CUSTOMER APPROVED:		RACE MODEL:	
VISION DISPLAY SOLUTIONS		CUSTOMER MODEL: RTP-065	
SCALE	UNIT	DESIGNED	CQL
1:1	mm	CHECKED	LCB
REV	Ver.1	APPROVED	PGJ
	SIZE A3	SHEET	1 OF 1

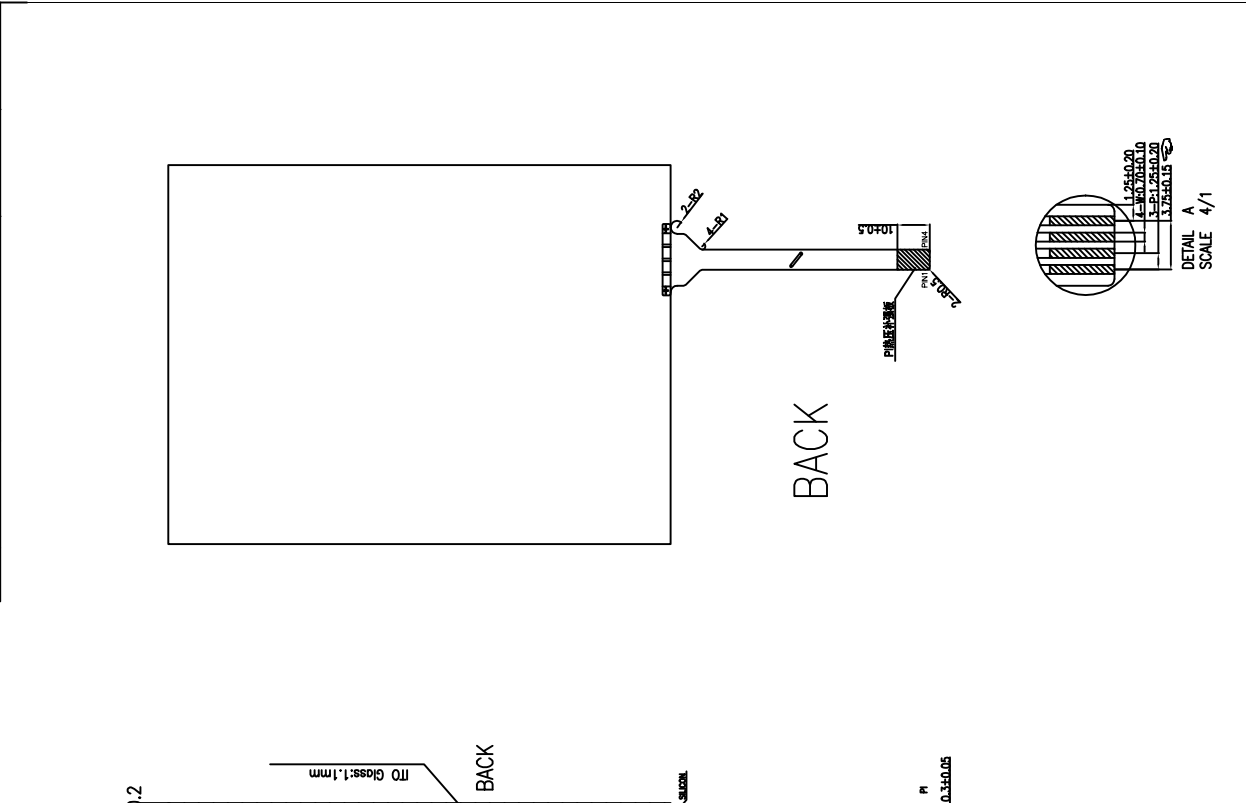
Please double check the points marked in finger.
